STAFF RECOMMENDATION
2007 Eastland Avenue
August 17, 2016

Application: Setback determination
District: Lockeland Springs-East End Neighborhood Conservation Zoning Overlay
Council District: 06
Map and Parcel Number: 08306029800
Applicant: Chris & Molly Bradstreet
Project Lead: Melissa Baldock, melissa.baldock@nashville.gov

Description of Project: Application is to reduce the side setback of a previously-approved DADU. The side setback was previously approved at three feet (3') and the applicant is seeking to reduce it to one foot (1'). The height, scale, materials, orientation, proportion and rhythm of openings, and roof form of the proposed DADU will not be changed from what was previously approved.

SITE PLAN
SCALE: 1/8" = 1'-0"

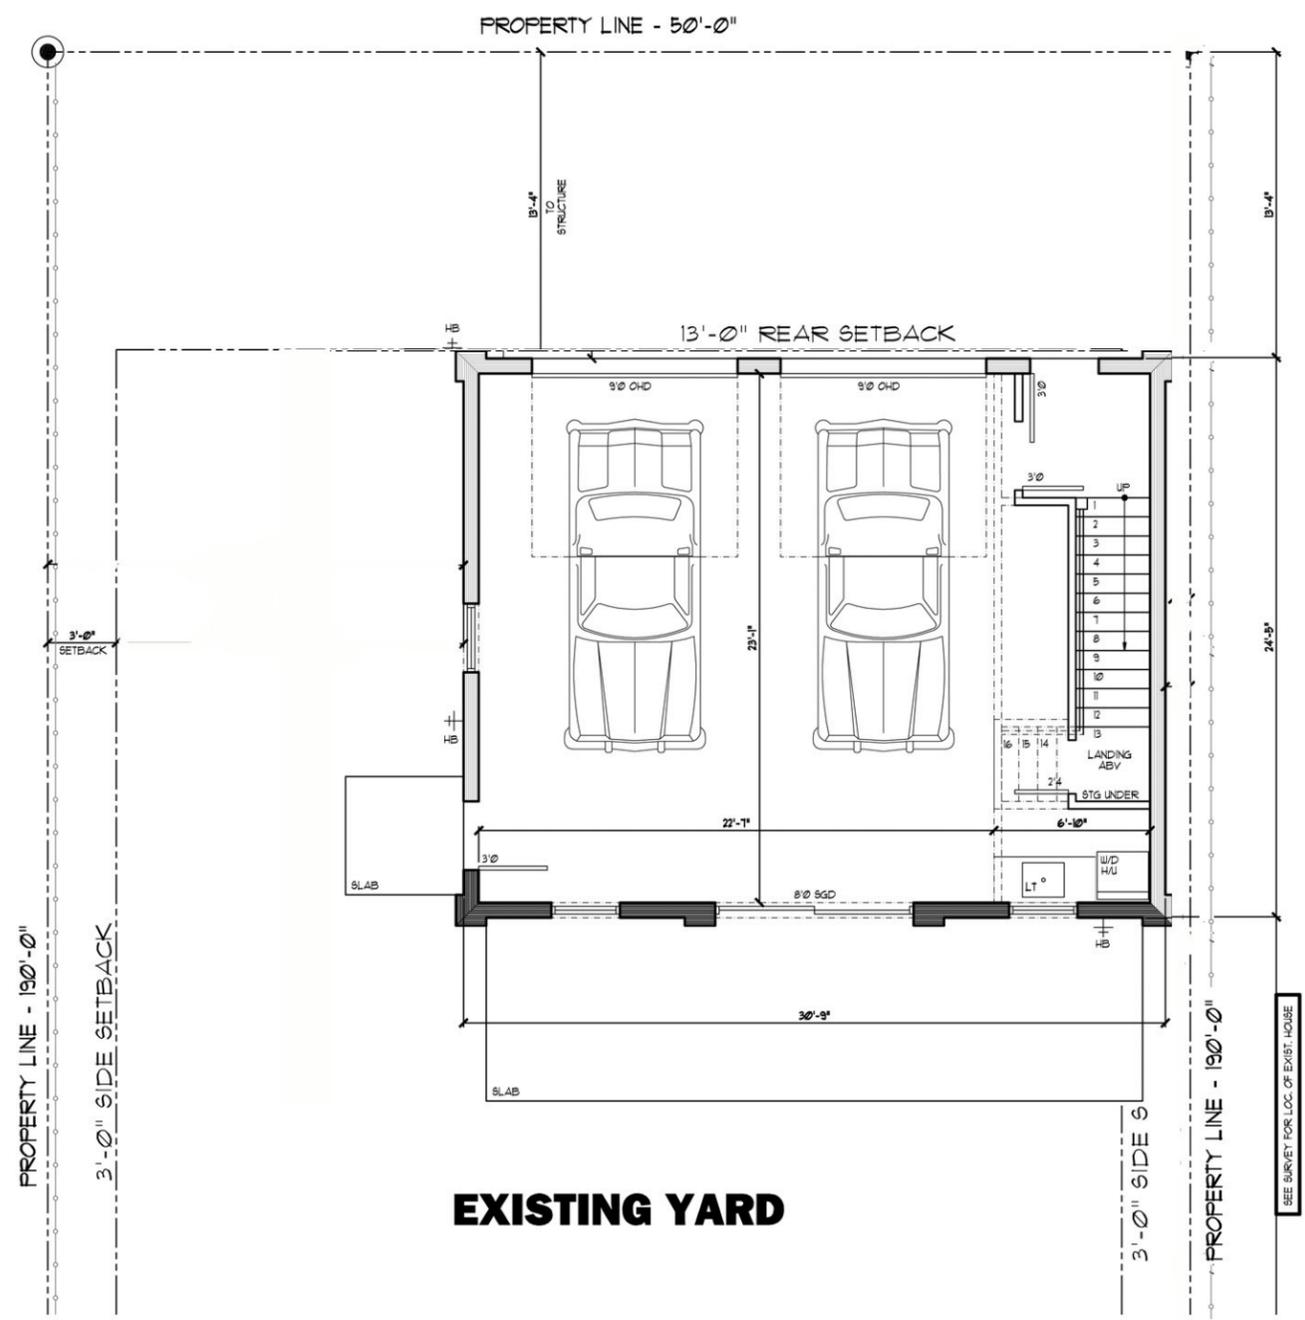
Setbacks: The proposed DADU requires a side setback determination. When an outbuilding has a footprint greater than seven hundred square feet (700 sq. ft.), base zoning requires that the structure be located twenty feet (20') from the rear property line and five feet (5') from the side property lines. MHZC approved the rear setback of thirteen feet (13') and a side setback of three feet (3') at the June 2016 public hearing. The applicant proposes to keep the thirteen foot (13') rear setback, but reduce the side setback to a minimum of twelve inches (12").

When the applicant submitted the materials for the DADU for the June 2016 MHZC meeting, the location of the right/east side property line was assumed to be at approximately the fence line. However, the survey from the Specific Plan (SP) townhouse development next door has shown that the fence is actually over the property line, and the existing outbuilding on the lot is very close to or on the property line (Figures 3, 4, 5, 6). The applicant intends to situate the new DADU in approximately the same location on the lot as the existing garage, and is therefore seeking to situate the DADU a minimum of twelve inches (12") from the side property line.

Staff finds the proposed minimum twelve inch (12") setback to be appropriate for this location for several reasons. The existing outbuilding that is to be demolished is very close to or on the side property line, so the new DADU will not be significantly different than the current conditions. In addition, the side property line abuts a large, multi-family townhouse development that was approved as a Specific Plan (SP). The site plan for the SP development shows that there will be approximately twenty six feet (26') of space in between the shared property line and the closest building on the SP site. This space will be used as the vehicular access for many of the units, and it is highly unlikely that it will be built upon in the future. The twelve inch (12") side setback will not negatively affect the SP development. A reduced side setback of twelve inches (12") would likely not be appropriate for most residential lots in Eastwood and other similar historic or conservation zoning overlays, but it is for this site because of the existing outbuilding and because of the SP townhouse development next door.

Recommendation Summary: Staff recommends approval of the setback determination, finding that it meets Ordinance 17.16.030. G. and Sections II.B.1.c. and II.B.1.h. of the *Eastwood Neighborhood Conservation Zoning Overlay: Handbook and Design Guidelines*.
